Invalid Application

Licence application number: PAN-014665

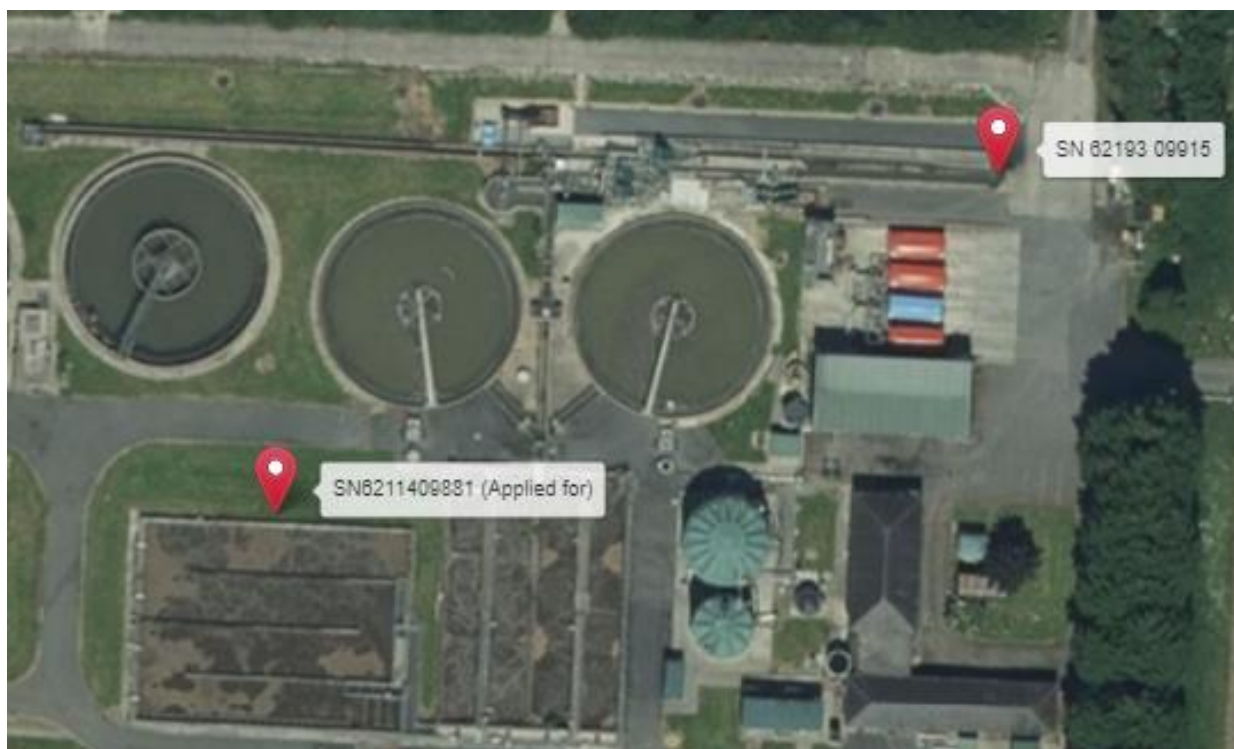
According to your submitted WRD form, you have stated that the discharge point is at NGR SN6211409881. According to the site plan you provided, the discharge point is at the existing inlet works adjacent to Primary Settlement Tank No. 1.

I therefore consider the discharge point to be at SN 62193 09915 (See below).

Can you confirm that my understanding is correct?
